MONTGOMERY COUNTY HISTORIC PRESERVATION COMMISSION
STAFF REPORT

Address:	7300 Maple Avenue, Takoma Park	Meeting Date:	1/22/2025
Resource:	Contributing Resource Takoma Park Historic District	Report Date:	1/15/2025
Applicant:	Michael Blunschi (Lumina Solar Services, Agent)	Public Notice:	1/8/2025
Review:	HAWP	Tax Credit:	No
Case No.:	1096389	Staff:	Laura DiPasquale
Proposal:	Solar panel installation

Figure 3: The roof plan shows the proposed location of the solar panels and the equipment location.

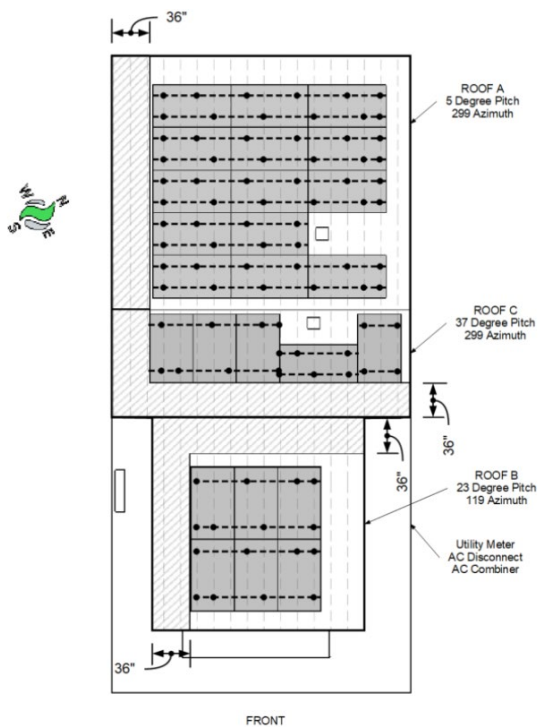
The applicant proposes to install 25 roof-mounted solar panels in three arrays, including six panels proposed on the street-facing front dormer roof and 19 panels on the rear-facing roofs (Figure 3). The Rec Alpha Pure 2 Series panels will each measure approximately 73.4 inches by 40.9 inches. The panels will be mounted to the asphalt shingle dormer roof with Unirac Sim mounts (Figure 4). The load center and disconnect switch are proposed adjacent to the existing utility meter on the right side elevation.

Figure 5: The proposed panel layout with staff-recommended adjustment (shown in red).

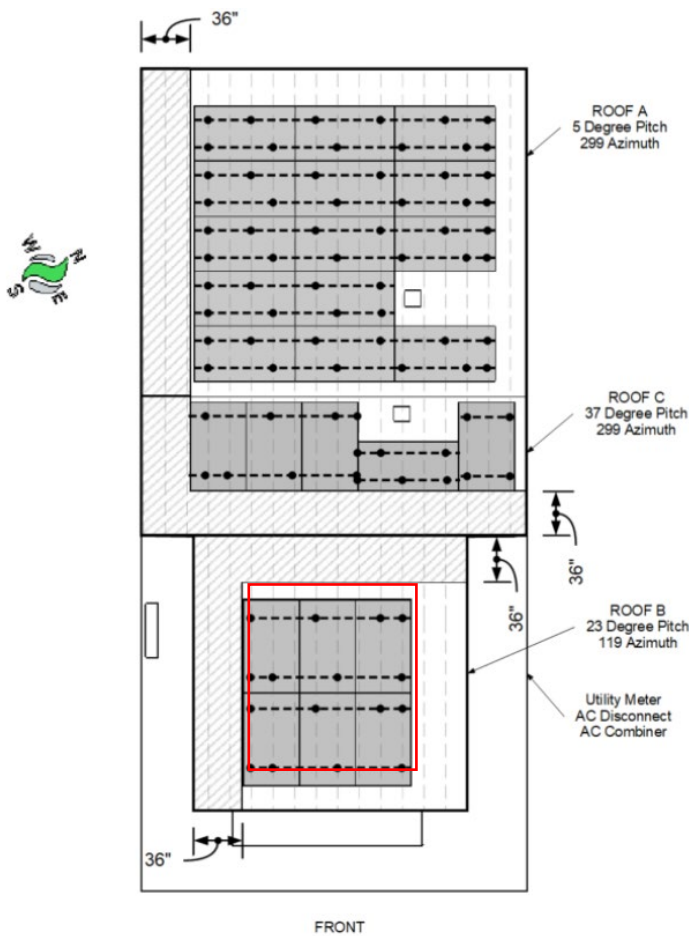
Staff acknowledges that the front-facing panels will be visible from the public right-of-way, but does not find the installation of the panels and associated equipment will affect the surrounding streetscape or landscape and impair the character of the historic district. As presented, the applicant proposes to install the six panels in a symmetrical pattern, which will minimize their visual impact. Staff recommends that, to further reduce their visual impact and be compatible with the symmetrical nature of the dormer below, the applicant center the panels on the dormer roof and shift them slightly farther away from the front roof edge, to the edge of the upper setback requirement (*Figure 5*).

1. The front-facing panels must be centered on the dormer roof and shifted to the upper offset line limit, away from the front roof edge.

1. The front-facing panels must be centered on the dormer roof and shifted to the upper offset line limit, away from the front roof edge;

Figure 6: Shade map and summary.

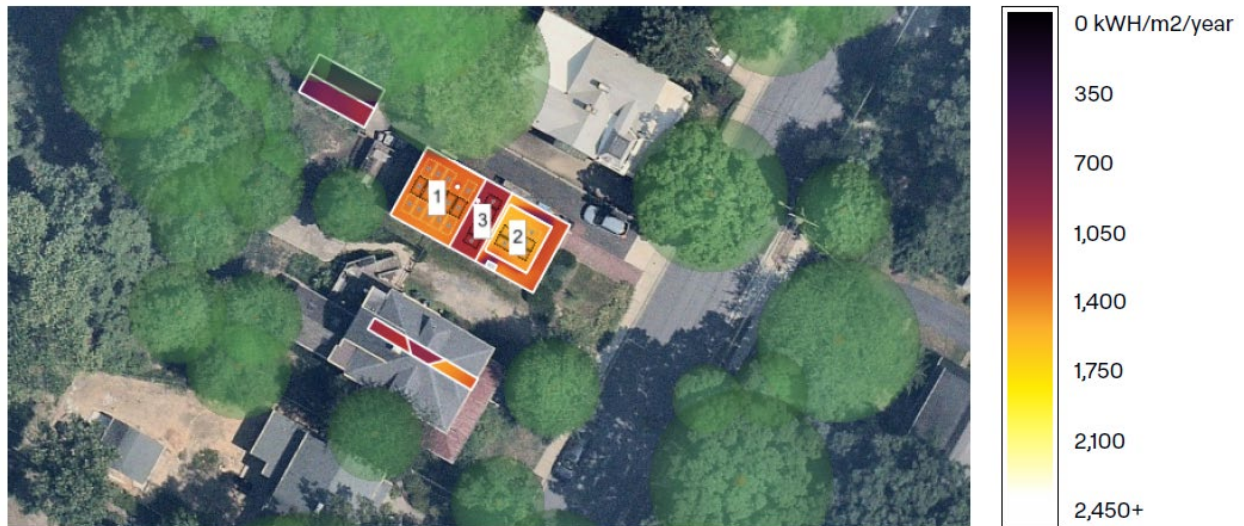
According to the shade map and corresponding statement provided by the applicant, the panels on the southeast-facing front dormer roof plane has the greatest annual tilt and orientation factor (TOF), annual solar access, and annual total solar resource fraction (TSRF) (*Figure 6*). The load center and disconnect

will be installed on the right-side elevation toward the front wall plane. Staff finds this location to be appropriate based on the existing presence of the electrical panel and meter.

Figure 7: Locations of Outstanding resources (yellow stars) in the viewshed of 7300 Maple Avenue (outlined in blue).

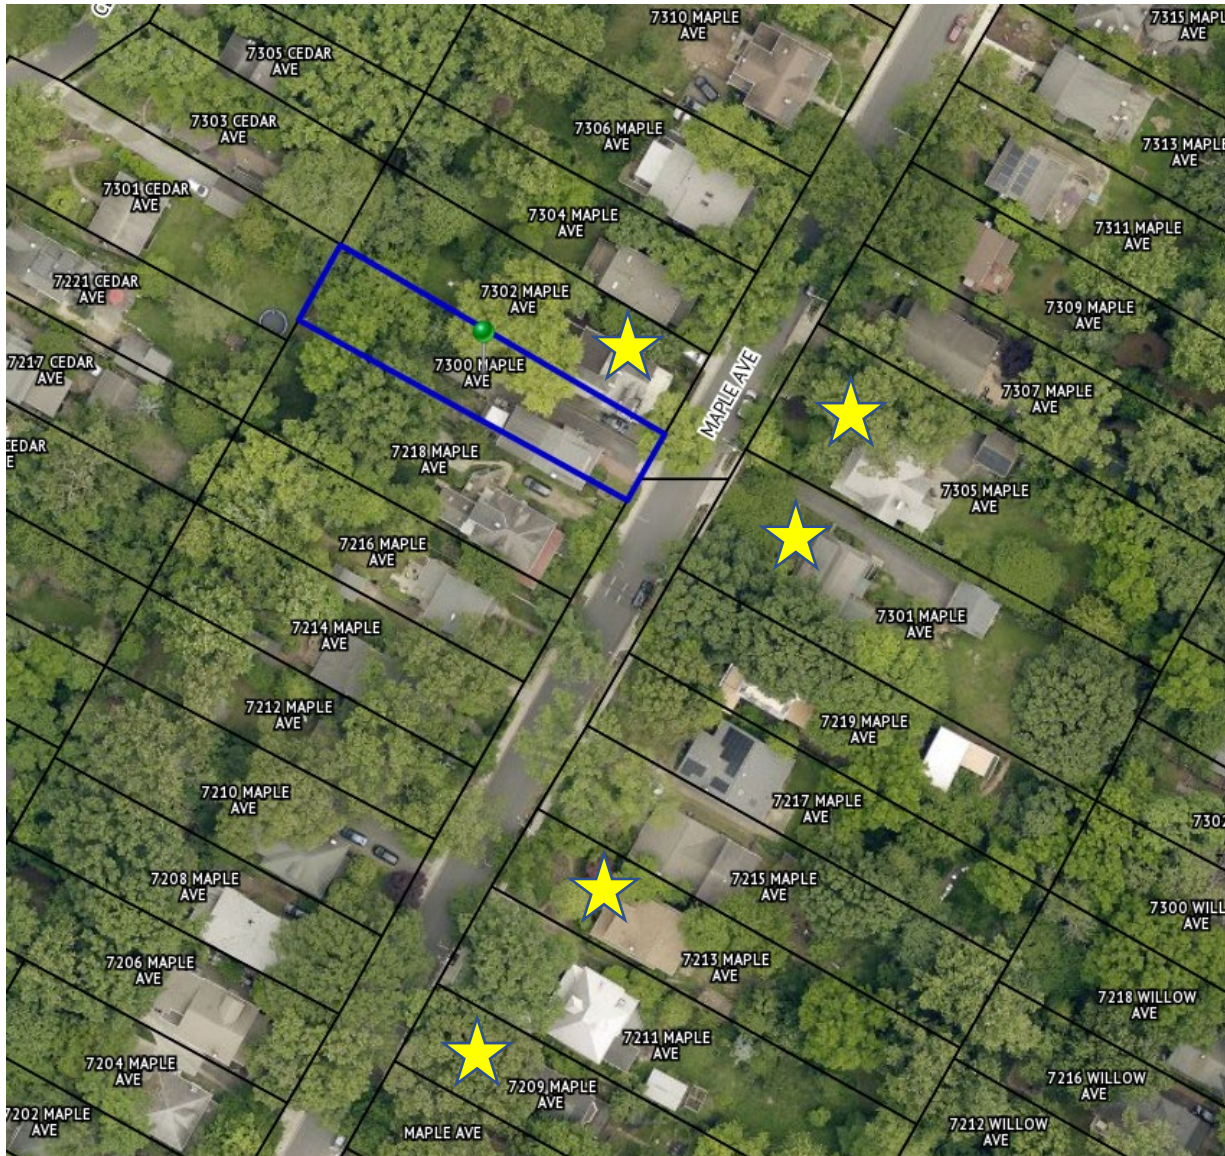
Five Outstanding resources will be within the viewshed of the panels (*Figure 7*): 7302 Maple Avenue (25 ft. northeast); 7301 Maple Avenue (45 ft. southeast); 7305 Maple Avenue (72 feet. northeast); 7213 Maple Avenue (204 ft. southwest); and 7209 Maple Avenue (310 ft. southwest).
